BOARD OF ADJUSTMENT MEETING CITY OF ST. PETE BEACH

Wednesday, October 27, 2021
2:00 PM

**PLANNING DIVISION
STAFF FINDINGS REPORT
TO THE
BOARD OF ADJUSTMENT**

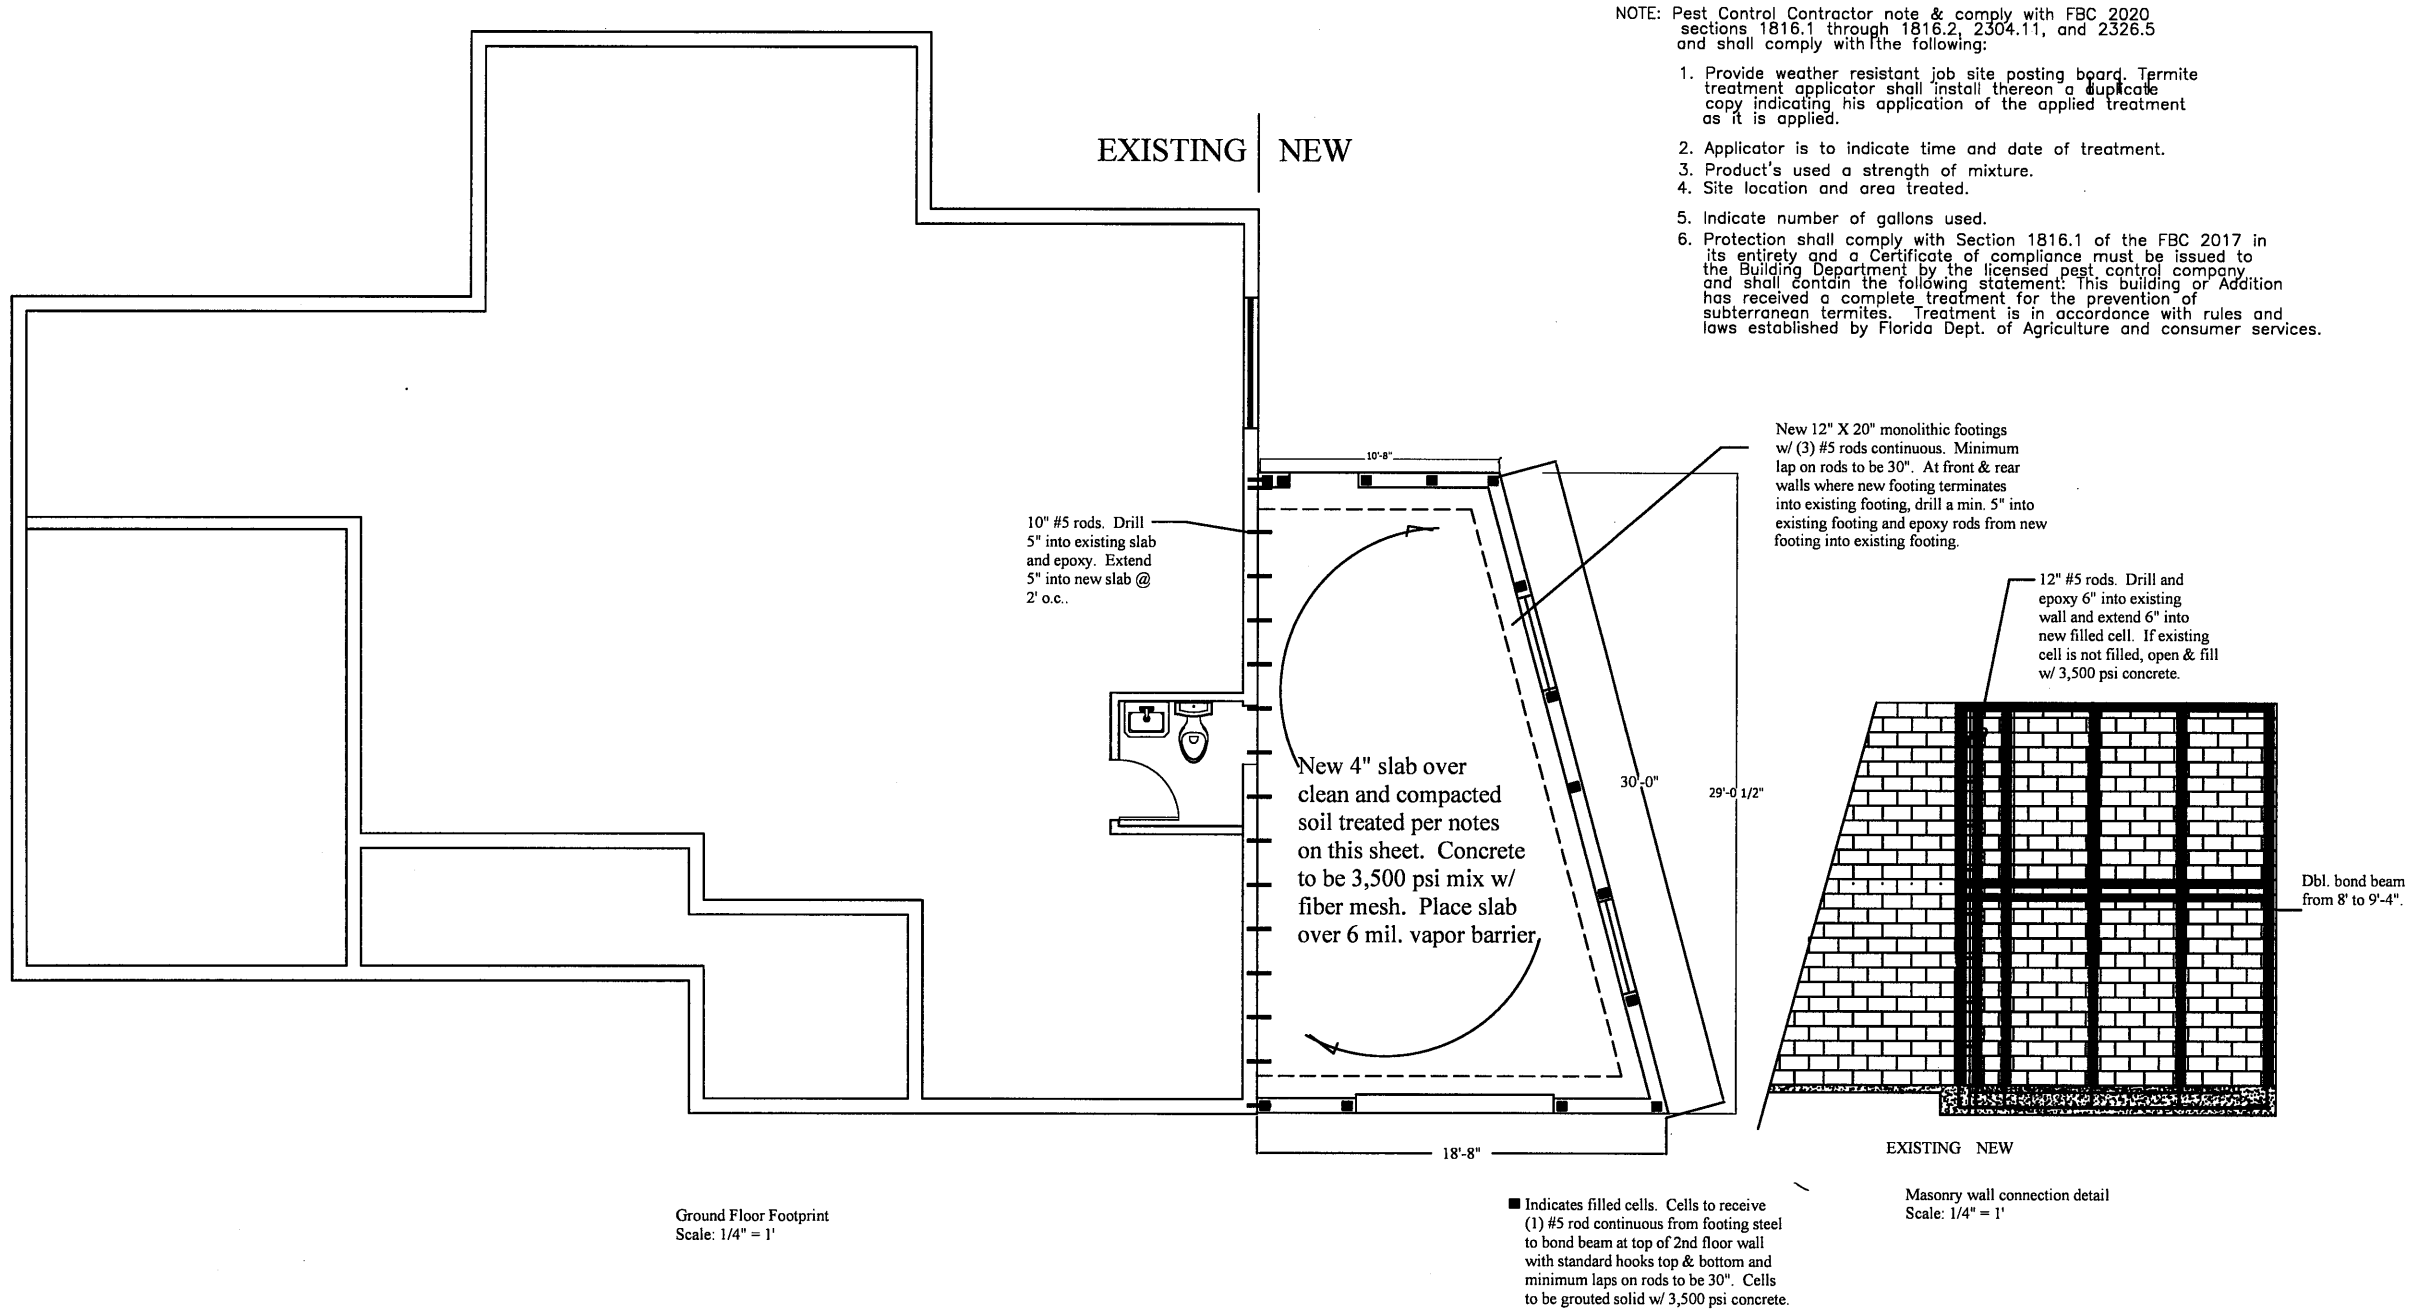
I have drawn a **yellow** circle around the area in question. This is the only area where the family can park their third vehicle. Also, this space does not give enough area to add on a garage. (Again, I feel like this is where the confusion lies between just adding “living space” to building a specific addition for a garage and garage storage space.

I went ahead and circled in **purple** where the driveway entrance would be used to access the addition of the garage. The family is trying to keep this area clear for garage use only. The area circled in **green** is the proposed space where the family is wanting to park their 3rd vehicle when family and friends are over so not to use any street parking of any kind.

PROPOSED FLOOR PLAN
Scale: 1/4" = 1'

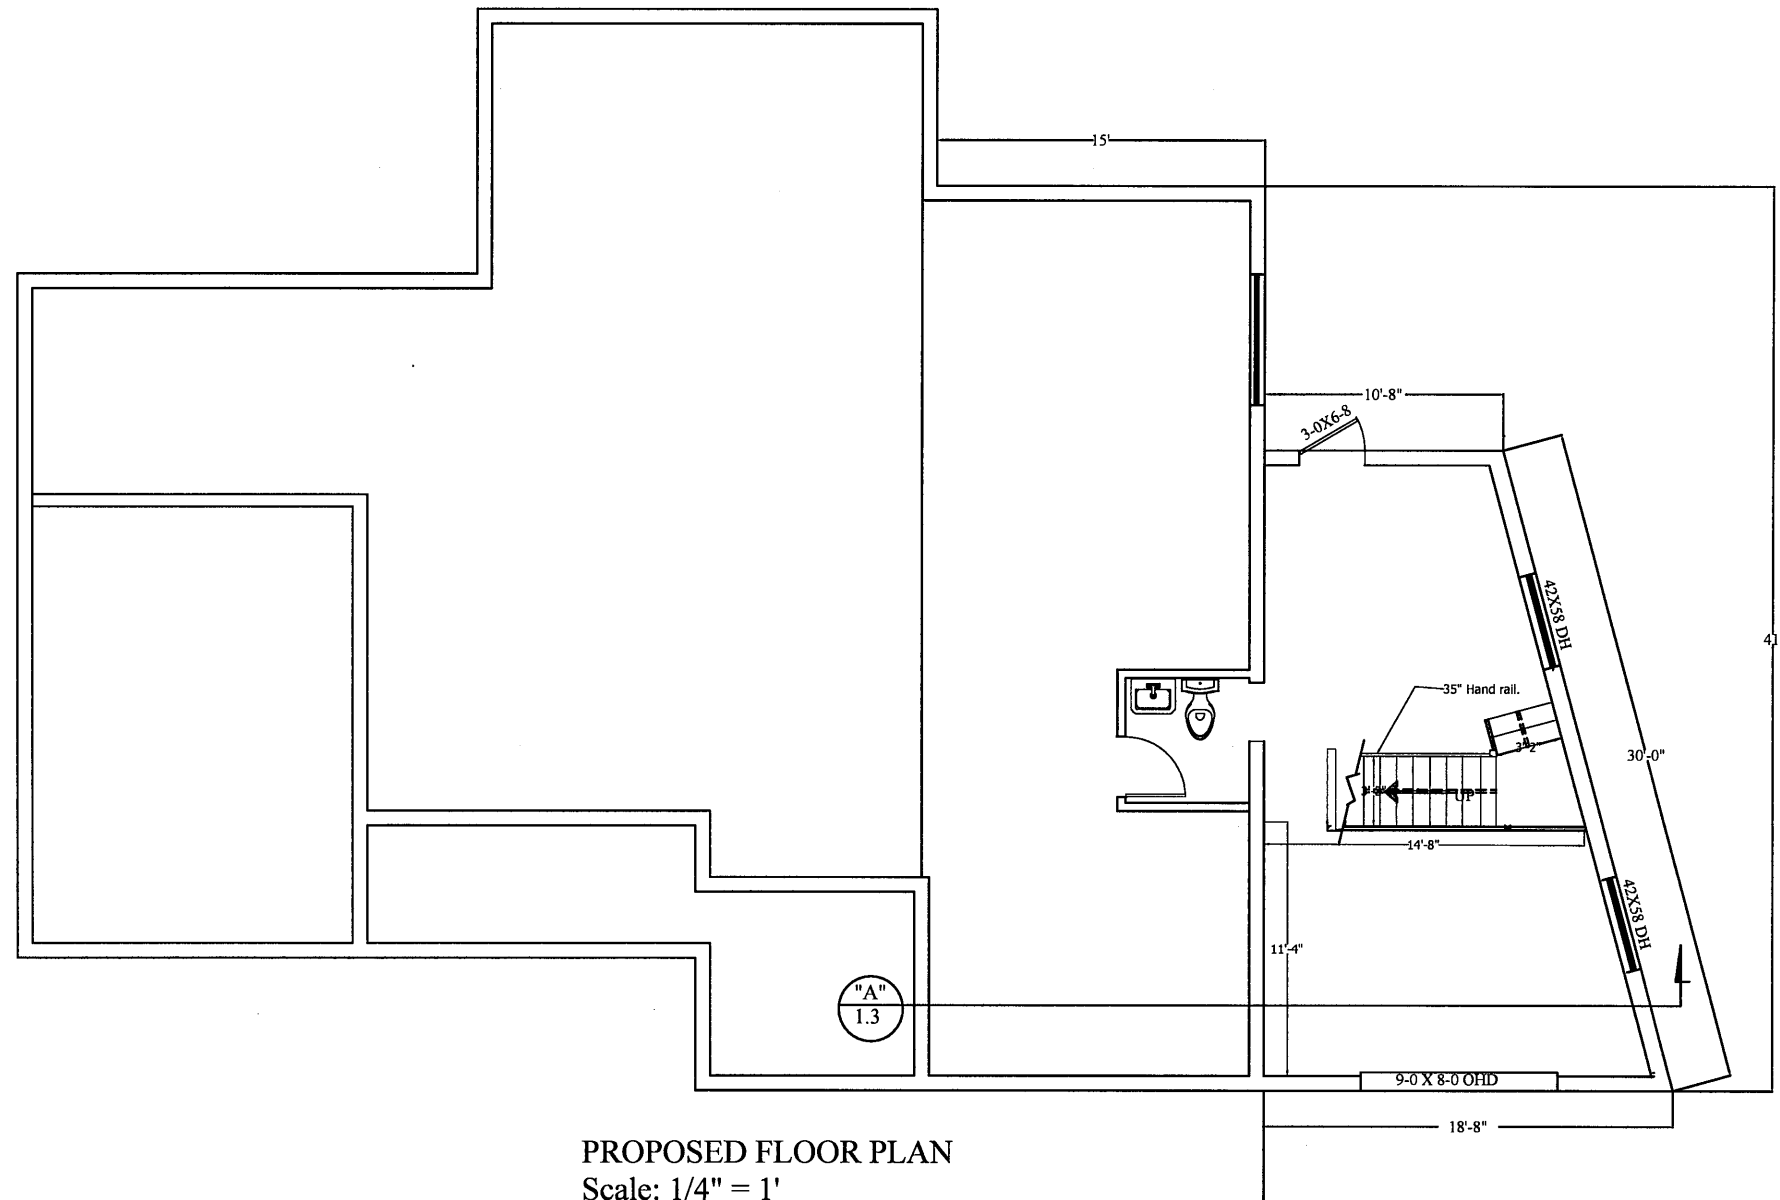
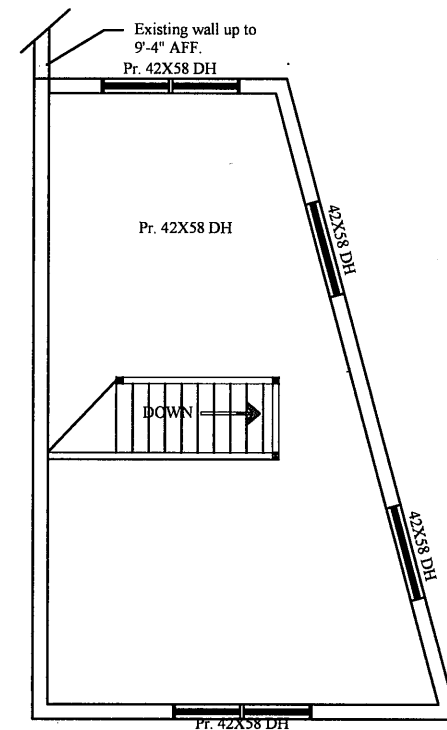
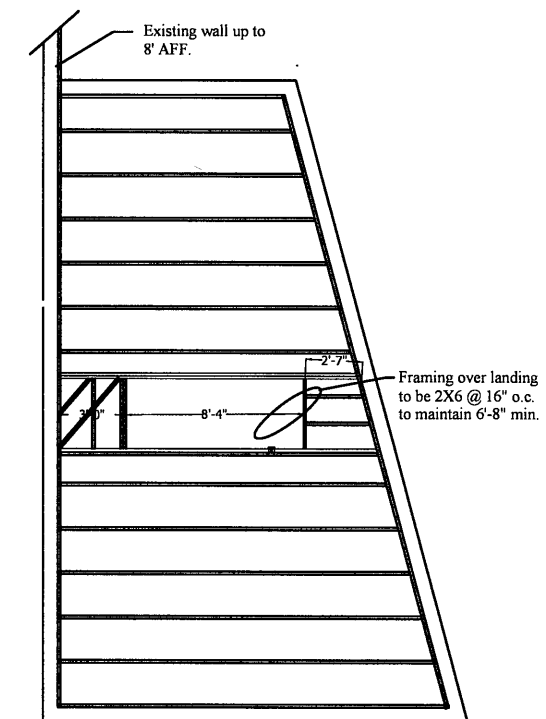
The applicant supplied supplemental responses that state this space is to be used as a garage with storage space above. However, the floor plans appear to show a space of only eleven feet in depth

2. *The addition slants from 10'-8" at the rear to 18'-8" at the front. The rear of the addition could be extended approximately 1.8' closer to the side property line without violating zoning standards. If you were to ask for a lesser front setback request, such as making the addition 12'x30', would that cause any issues relative to the intended floor plan for the addition?*

I had not looked at the space as a garage because, unless I'm misreading the plans, it looks like the depth of the addition between where the overhead door is located and the wall adjacent the walk-up is only about 11 feet in depth. I just don't see how that could fit even a compact SUV.

Currently, the property has no garage space. They currently have 3 vehicles with a growing family (Children under the age of 10) and would like to use the little driveway that they do have for family and friends to be able to park instead of parking on the busy cross street of 54th Ave and Bikini Way S. The garage addition would provide at least space for one vehicle including upstairs storage for tools, decorations, and even pool cleaning equipment that they just do not have.

1 SITE PLAN
SCALE: 1/8" = 1'-0"

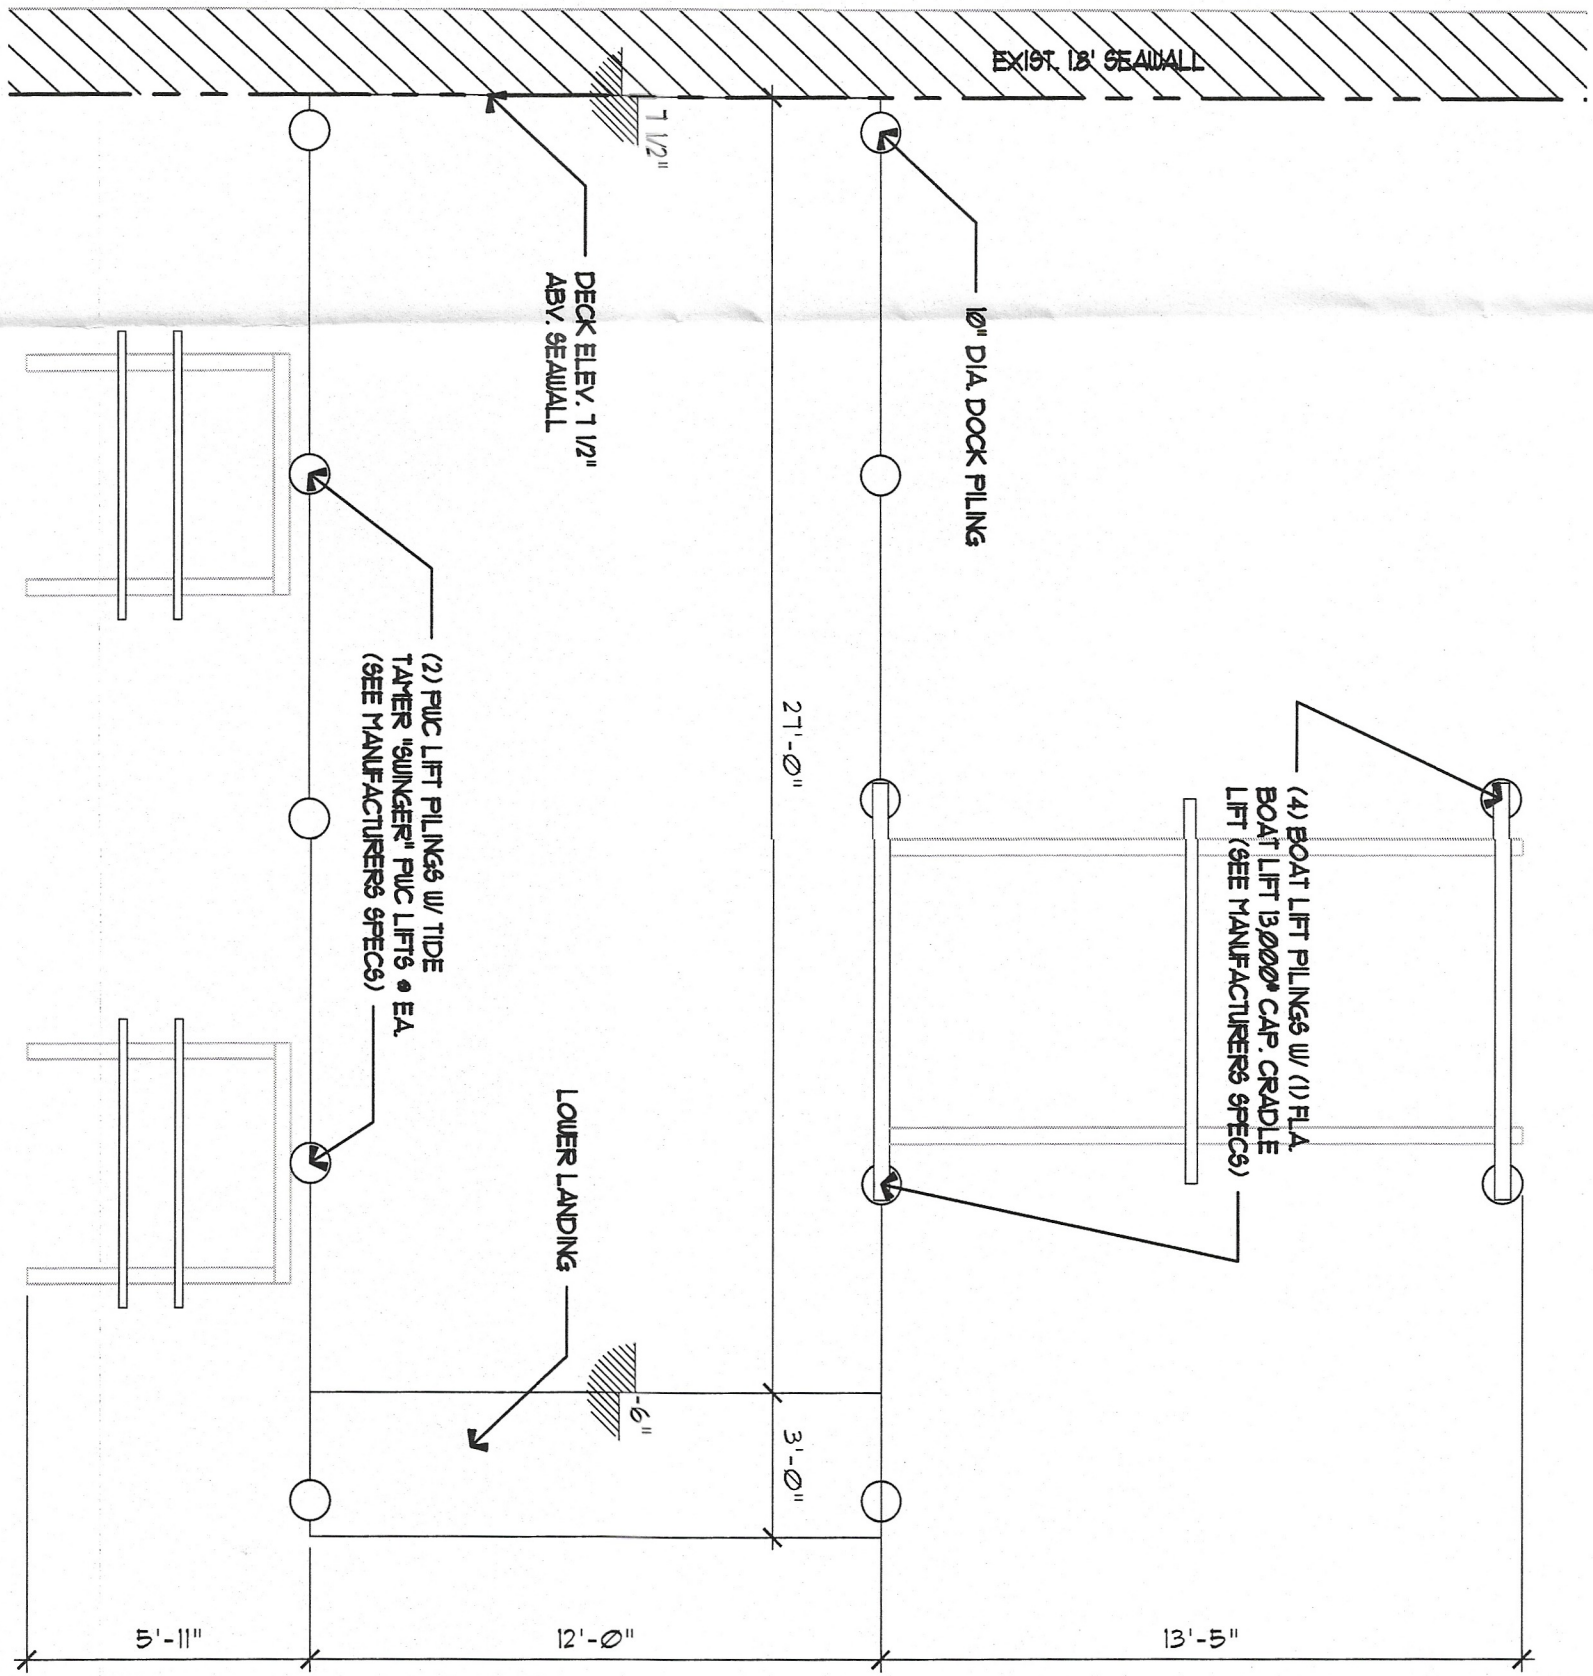
Staff find that the requested variance is not the minimum variance that makes possible the reasonable use of a proposed new dock structure that exceeds both the length and width requirements of the Land Development Code. Staff find that the subject dock could be modified in a manner that reduces the length and width to meet Code and still support a boat and jet ski lifts.

Staff recommend Denial of this request for a boat dock to exceed the allowable length and width as proposed.
